MIL-C-26482G
AMENDMENT 5
3 January 1991
SUPERSEDING
AMENDMENT 4
28 September 1984

CONNECTORS, ELECTRICAL, (CIRCULAR, MINIATURE, QUICK DISCONNECT, ENVIRONMENT RESISTING), RECEPTACLES AND PLUGS, GENERAL SPECIFICATION FOR

This amendment forms a part of MIL-C-26482G, dated 5 September 1975, and is approved for use by all Departments and Agencies of the Department of Defense.

FIGURE 5A: Pin contact, delete "MS3192" and substitute "MIL-C-39029/31"; Socket contact, delete "MS3193" and substitute "MIL-C-39029/32".

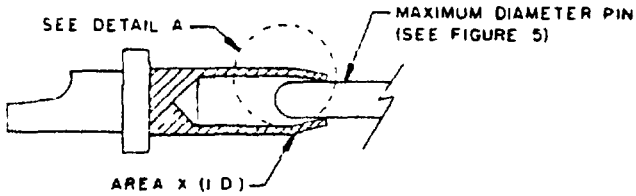
FIGURE 5B: Pin contact (Eyelet Termination), delete "MS3192" and substitute "MIL-C-39029/31".

FIGURE 5C Areas of applications of localized finish.

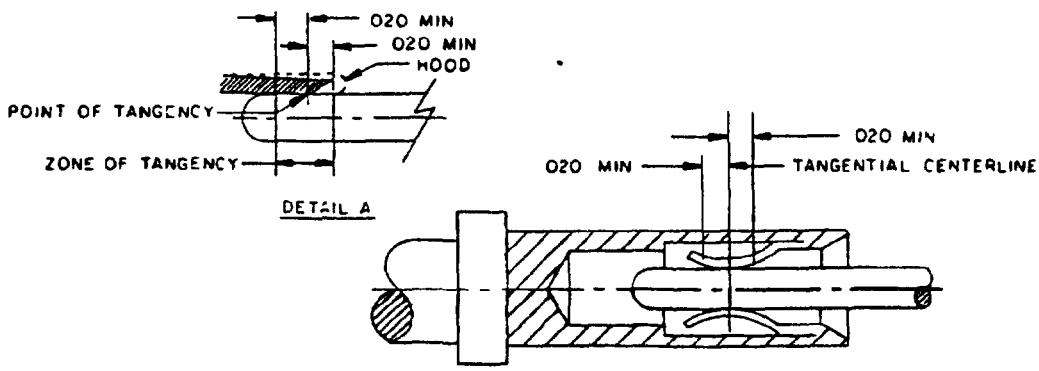
"3.3.5.1.2 Localized finish. Contact body shall have gold in accordance with MIL-G-45204, type II, grade C, class 1 applied to areas X and Y (see figure 5), as applicable. All other body surfaces shall be finished with gold in accordance with MIL-G-45204, any type and grade (no thickness specified). The entire surface of the contact body shall be nickel underplated in accordance with QQ-N-290, class 2, 0.00003 to .00015 inch thick. Gold discoloration in areas other than X and Y is acceptable."

* FIGURE 5C: Adding new figure on areas of applications of localized finish.

FIGURE 14 Plating thickness measurement - overall finish (series 1, solder).

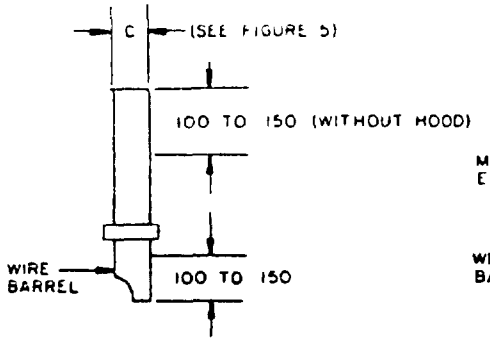
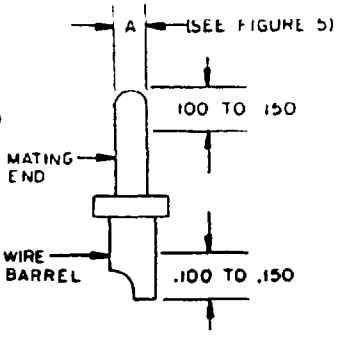
"4.6.51.1 Overall finish (see 3.3.5.1.1). Finish thickness shall be measured in accordance with MIL-G-45204. Measurements shall be made on the external surfaces of the contact body at the locations shown on figure 14.

Add new figures 14 and 15

FIGURE 15 Plating thickness measurement - localized finish (series 1, solder).

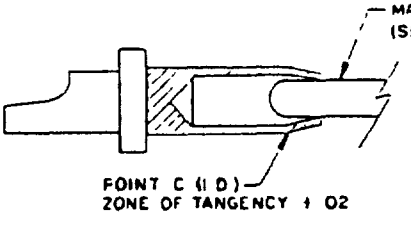
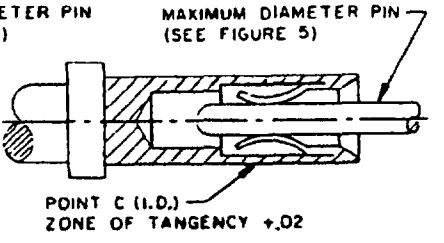
"4.6.51.2 Localized finish (see 3.3.5.1.2). Finish thickness shall be measured in accordance with MIL-G-45204. Measurements shall be made at point A or D of figure 15, as applicable.
